CHANGE ORDER

Project Name: **Haverhill Consentino Middle School** CO No. **14**

Architect's Project No. **21-0818**

See attached list of 6 item(s) for a total of **\$107,863.88**

JD-102, JD-103

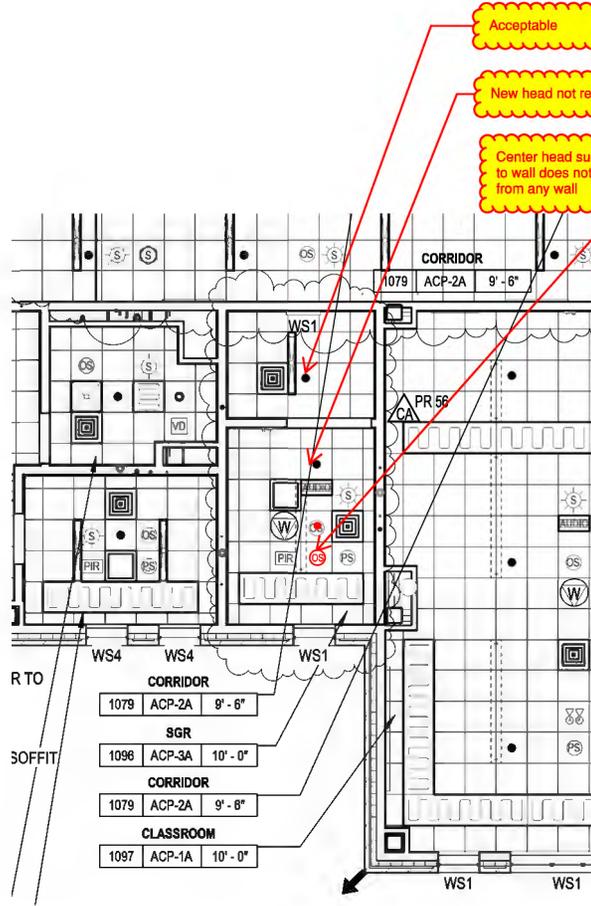
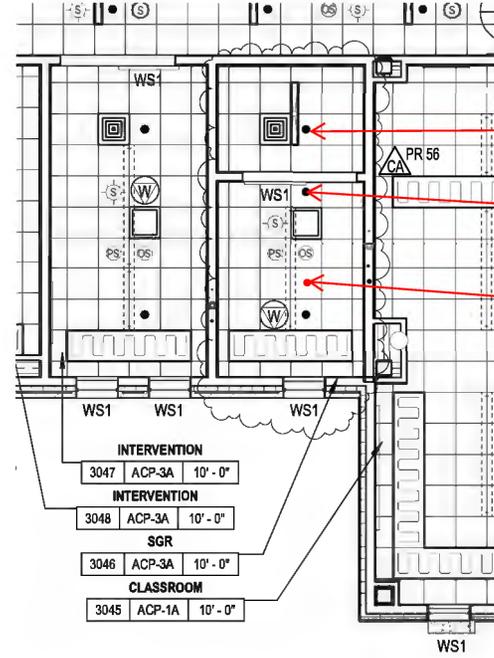
At Sheet A1.11 and AQ1.11, Level 1 – Area A/B, revise plan layout for SGR 1096 as shown on attached sketch **JD-102**. Make similar revisions to A1.31, AQ1.31, Level 3 – Area A/B, SGR 3046. At 3046, relocate floor box to be centered within room.

At Sheet A2.11, Level 1, Reflected Ceiling Plan – Area A & B, revise ceiling plan as shown on attached sketch **JD-103**. Make similar revisions at A2.31, Level 3 Reflected ceiling Plan – Area A & B. Attached sketch is intended to reduce length of existing lighting fixture, add additional fixture at break out space, add additional sprinkler to SGR. The intent of proposed ceiling plan is not to relocate previously coordinated / installed mechanical and fire protection that shall remain.

A1.13

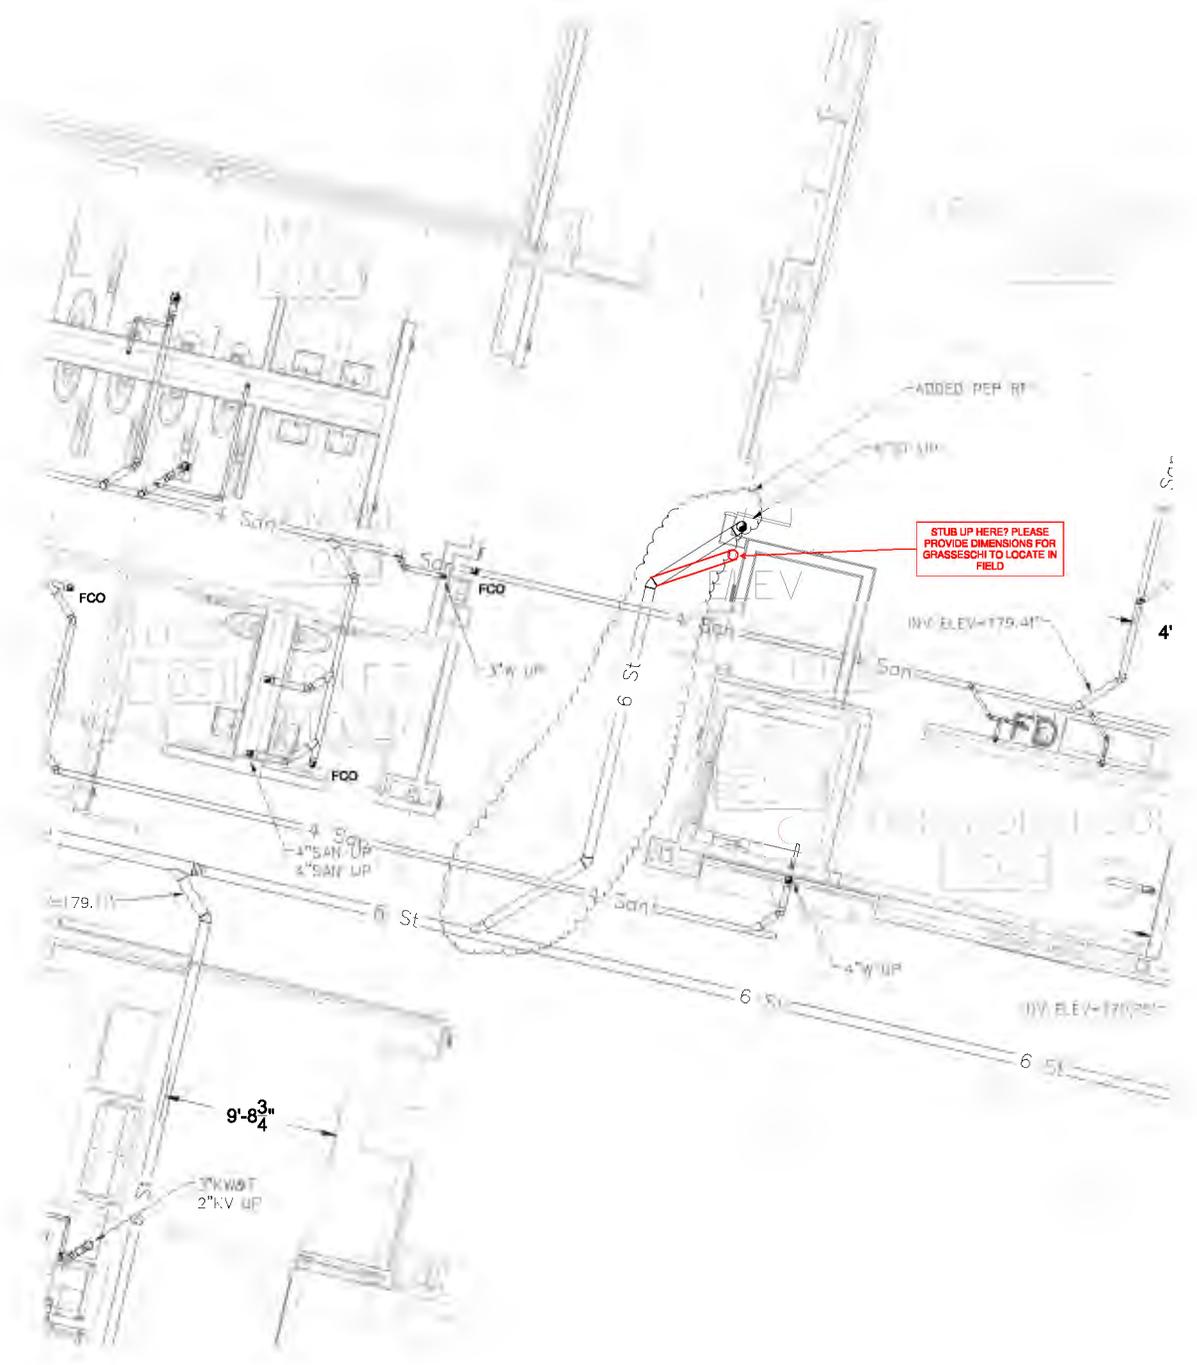
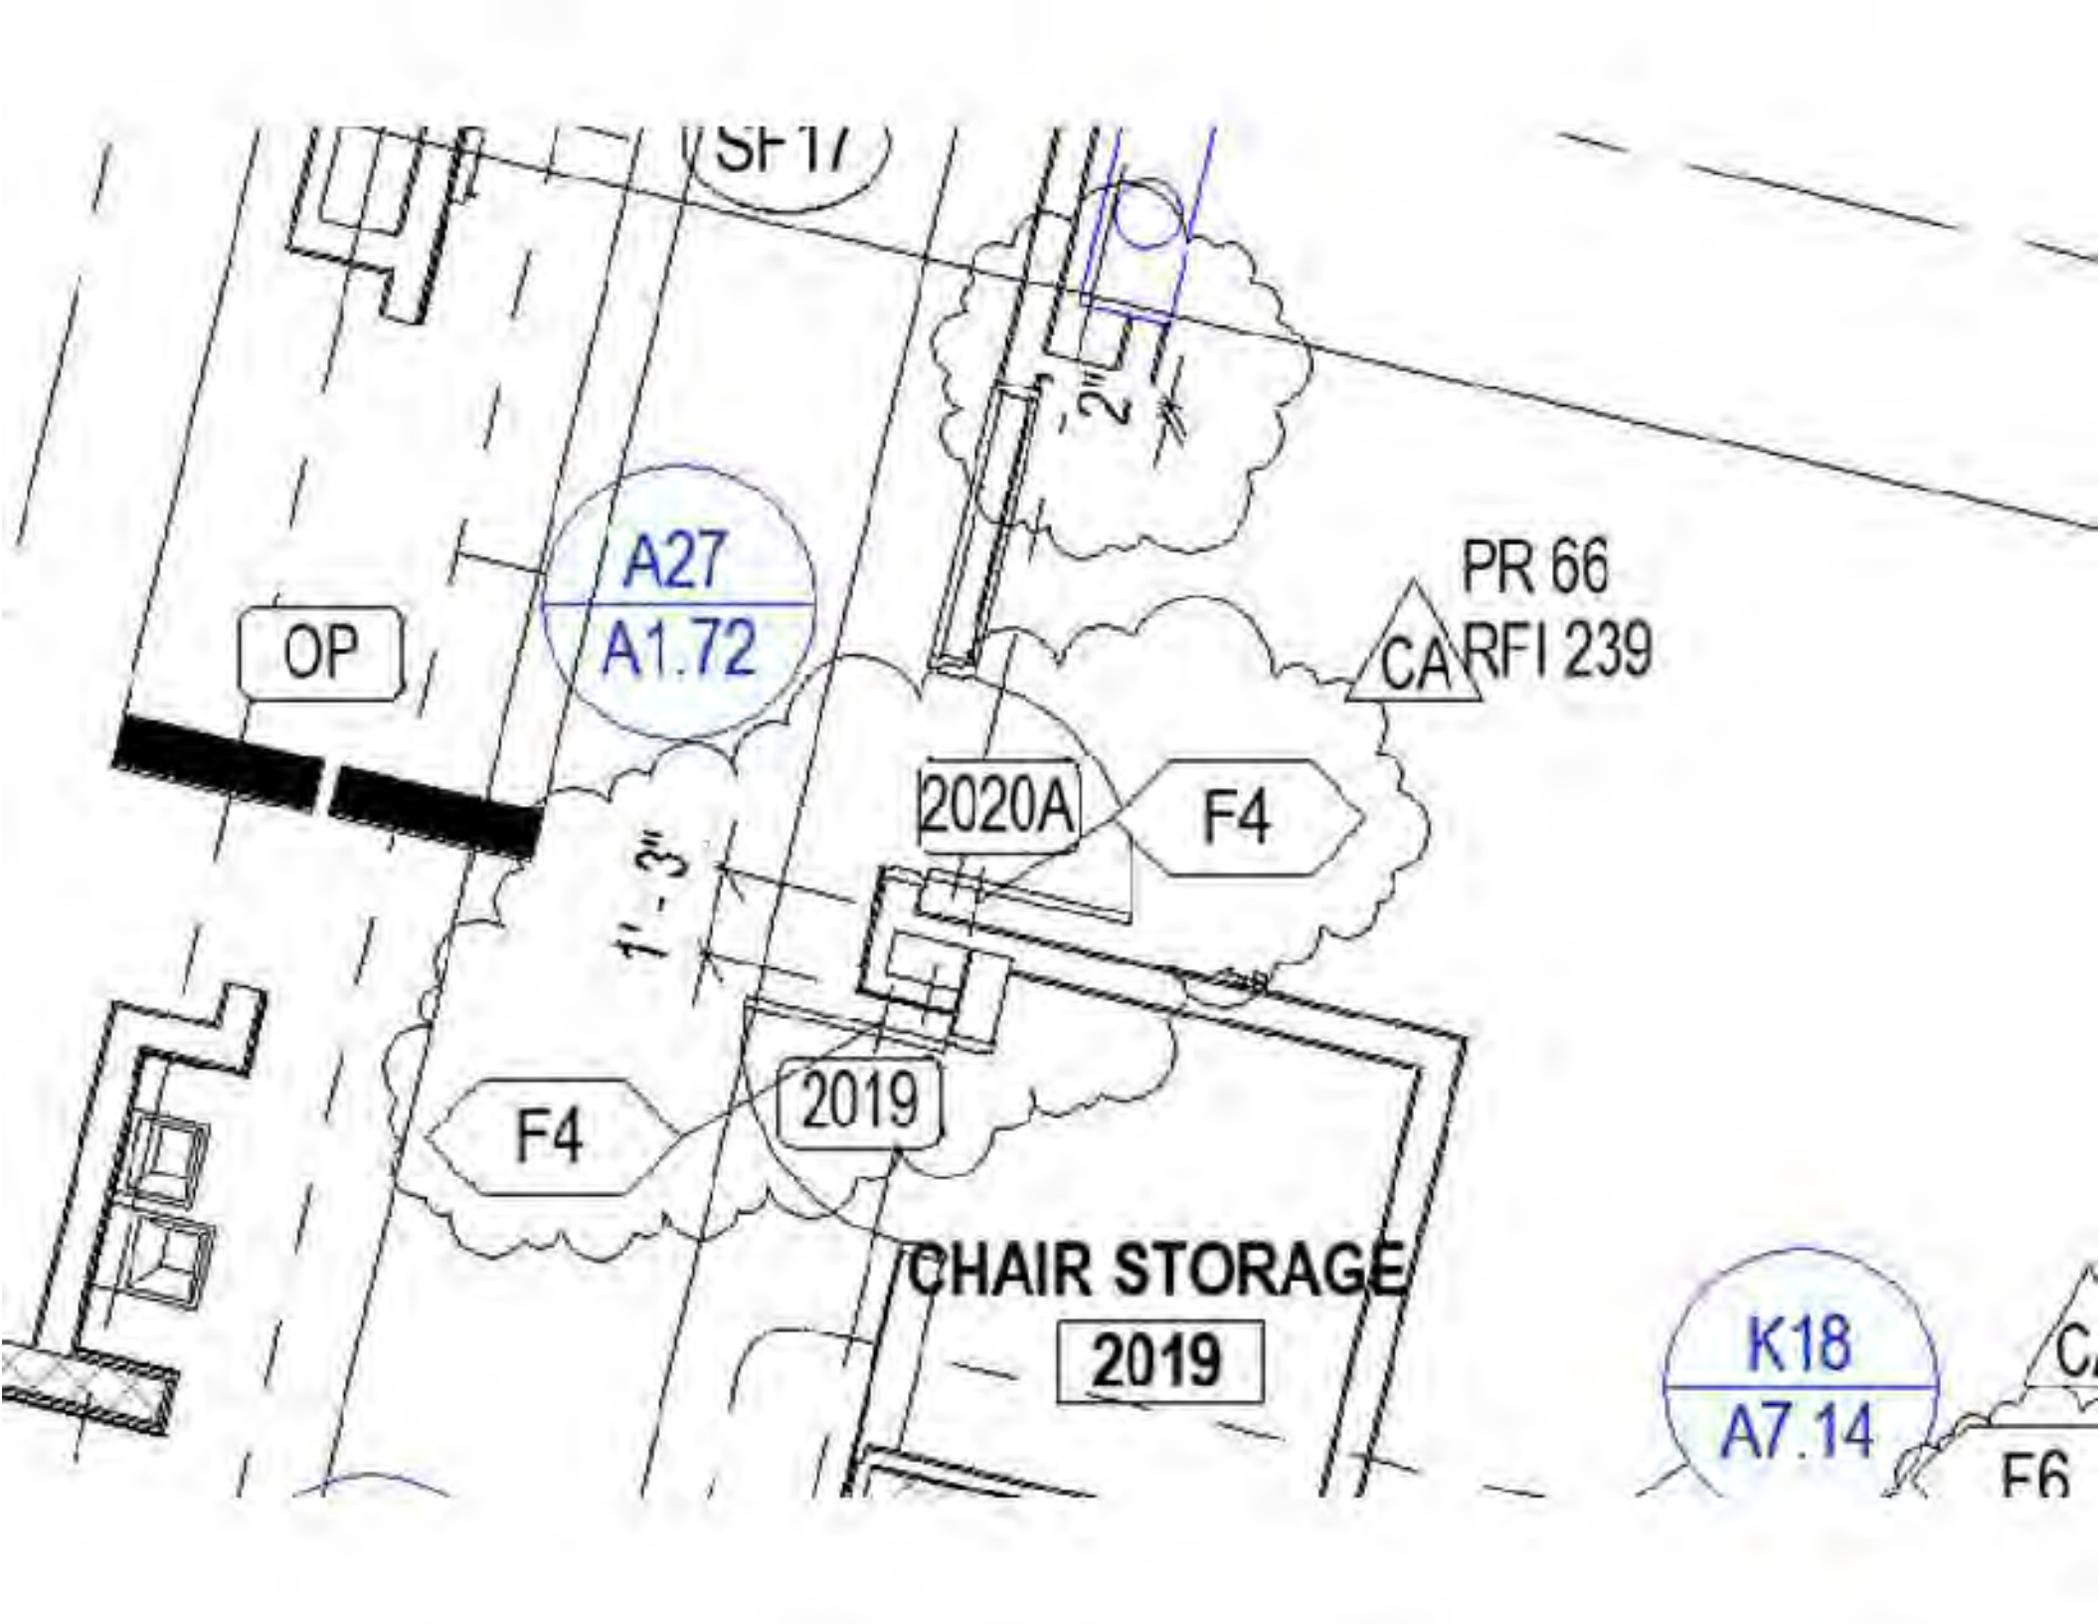
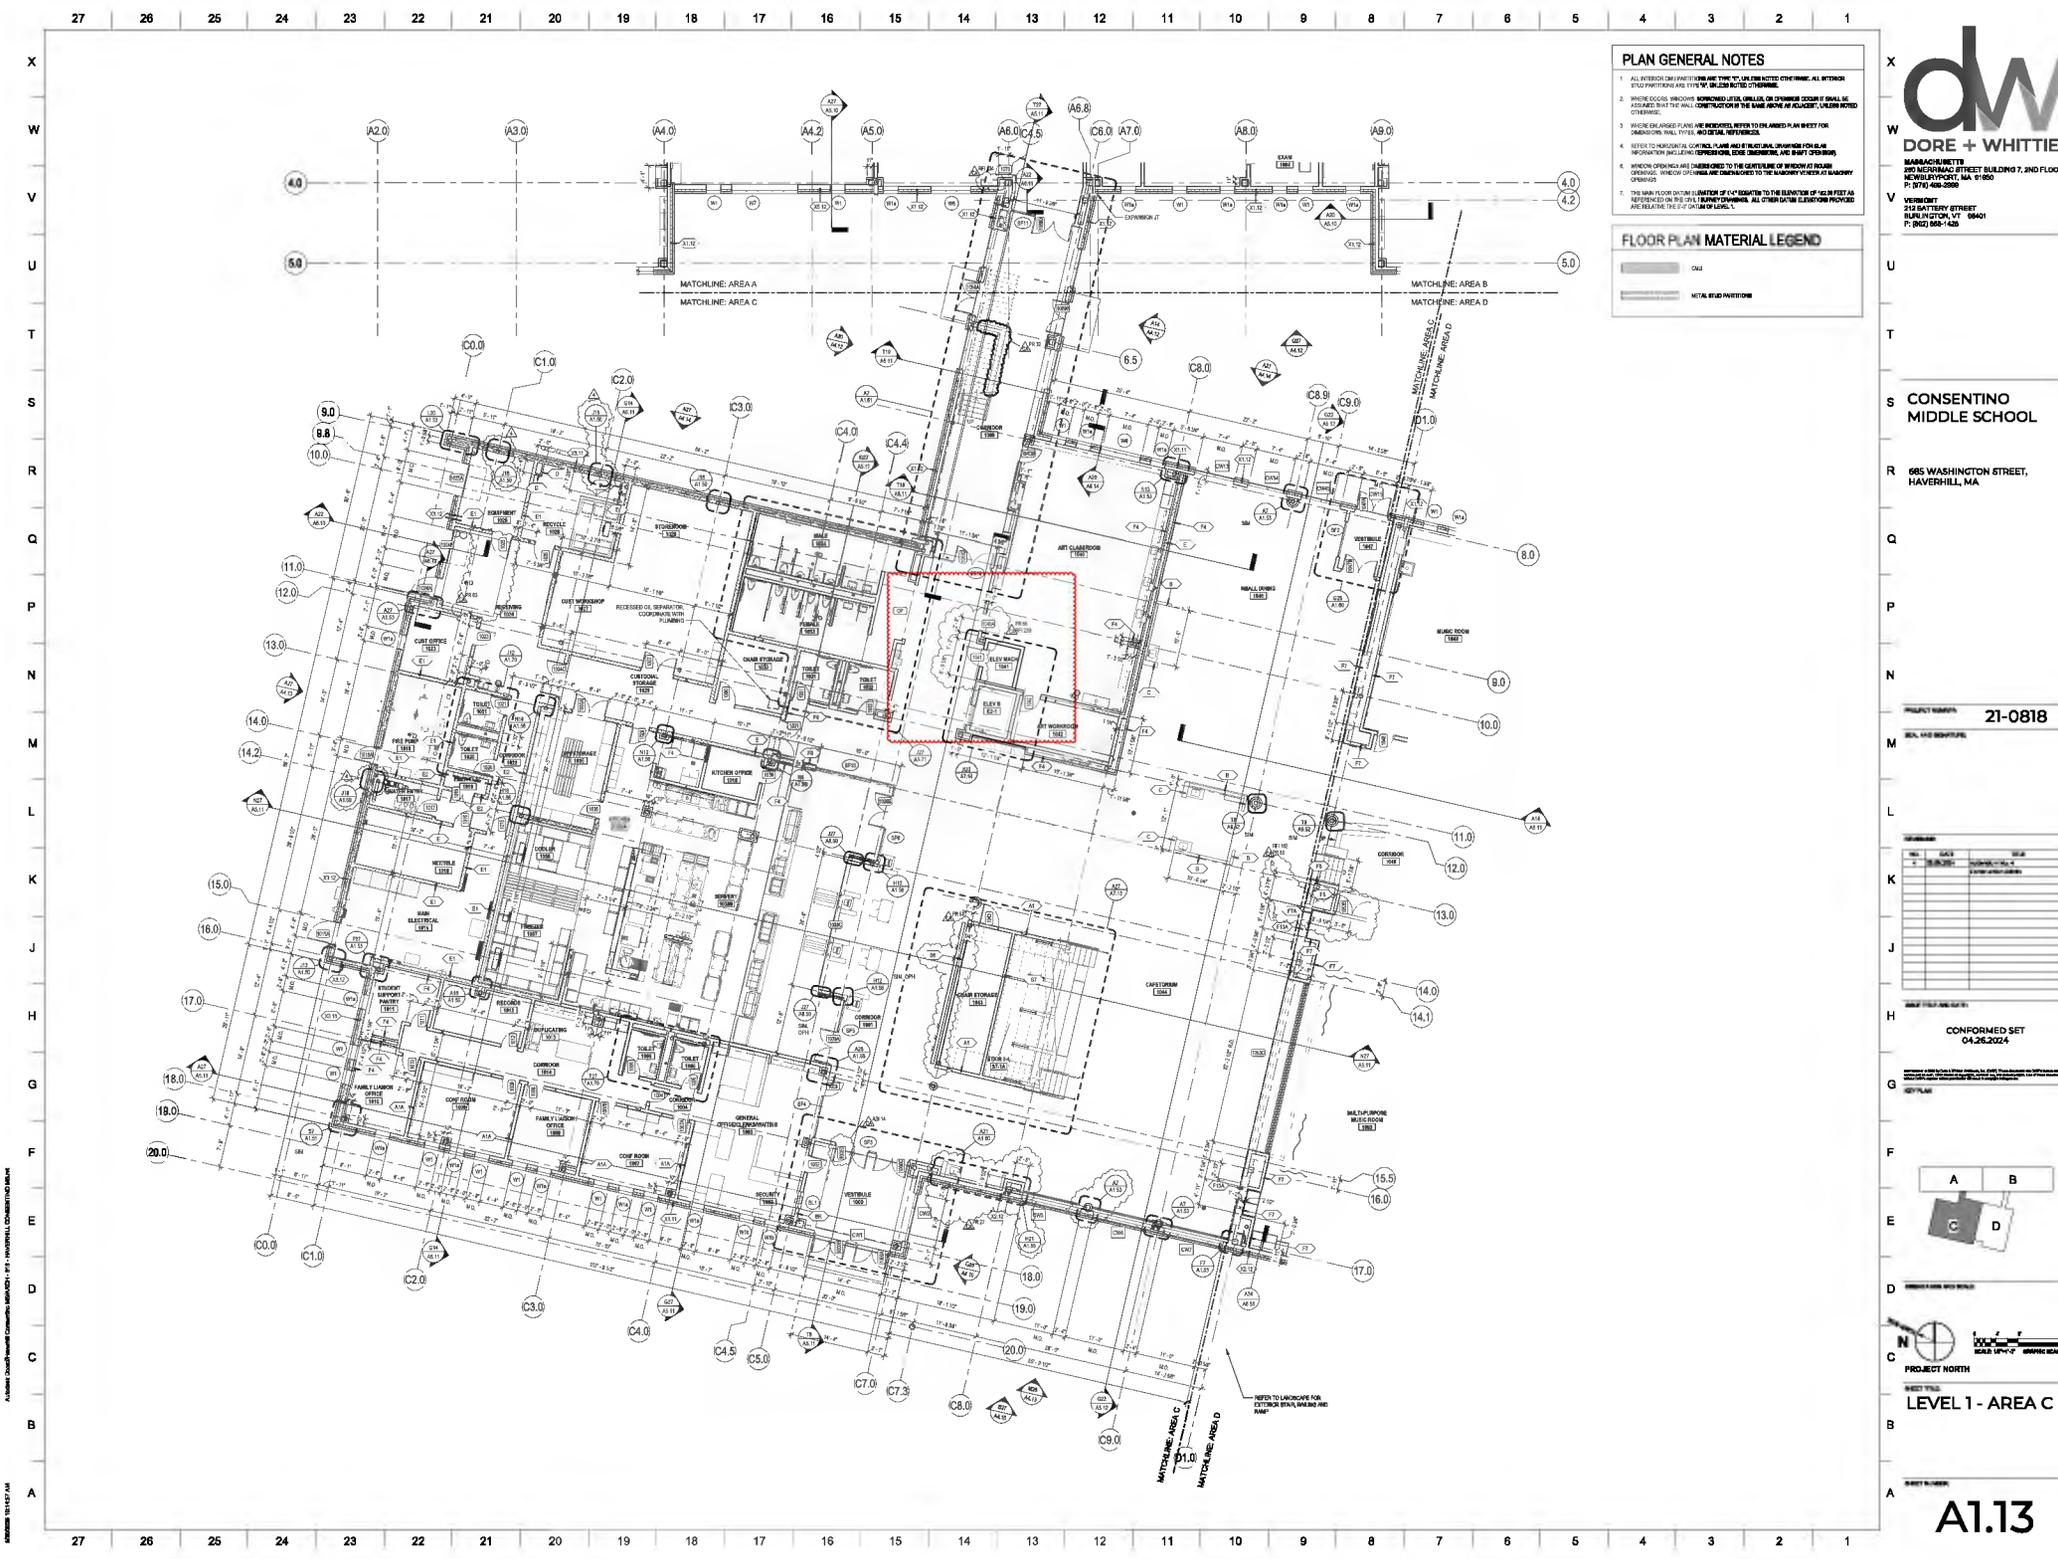
STUB UP HERE? PLEASE PROVIDE DIMENSIONS FOR GRASSESHI TO LOCATE IN FIELD

Refer to attached sheets for reference. Formal documents to be issued for record once all coordination is complete.

C6.01

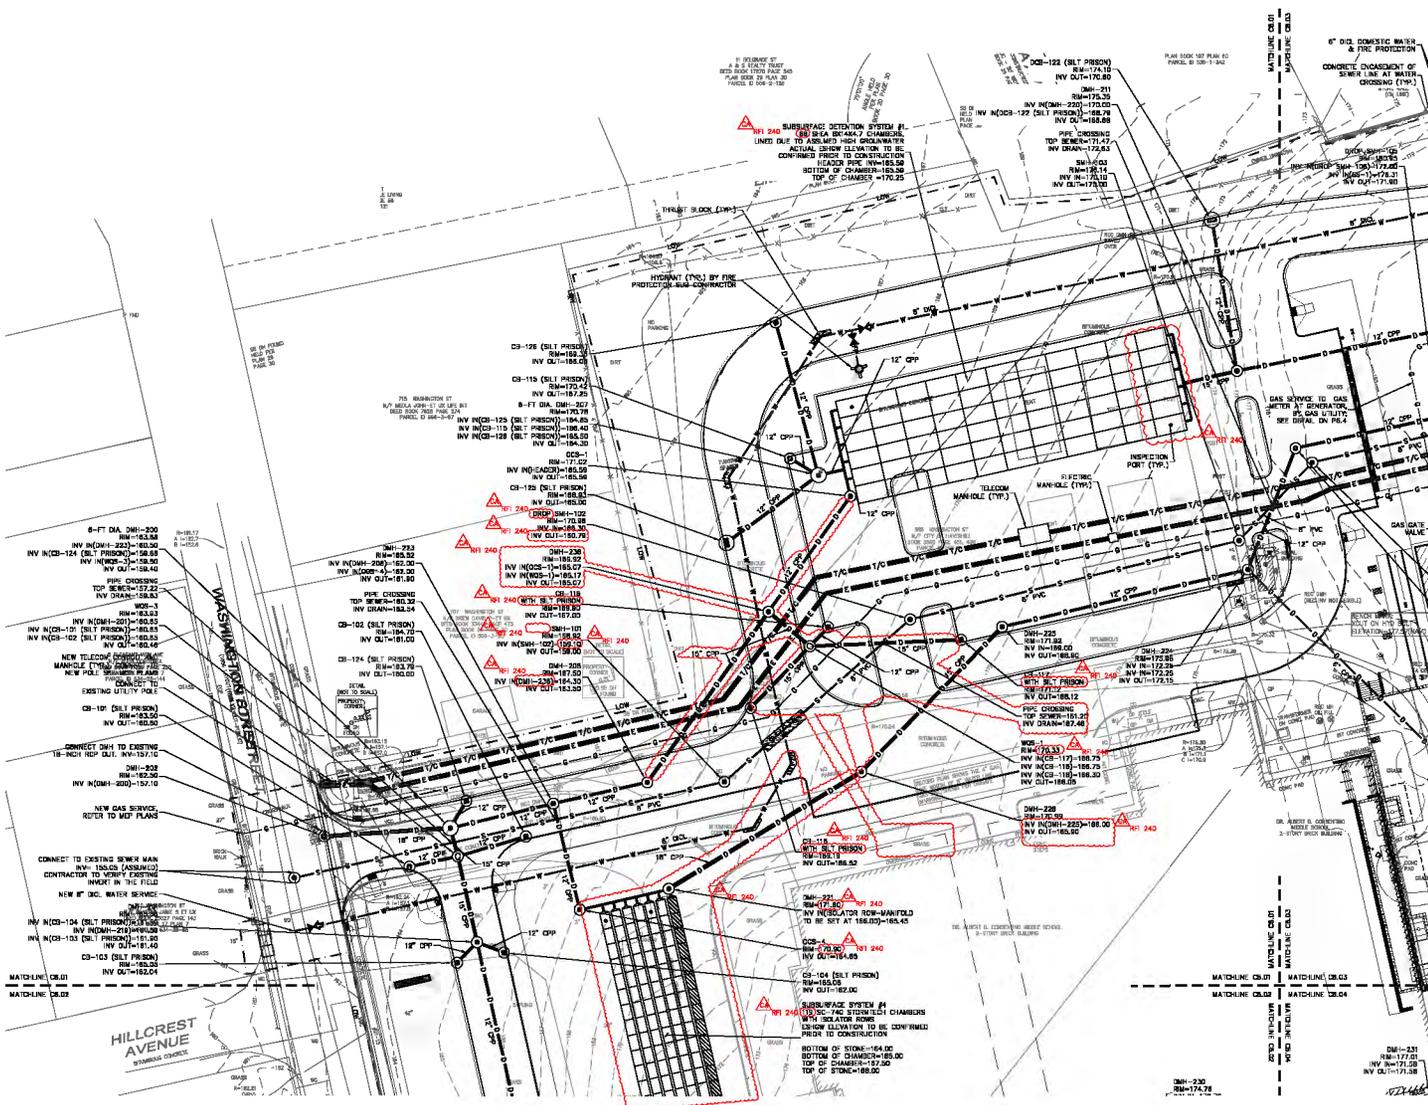
See attached Utility Plan C6.01 & advise if new manhole structure is needed to drop sewer line below existing ductbanks. Please also advise if new inverts are needed in SMH-101. See attached Derenzo as-built for reference.
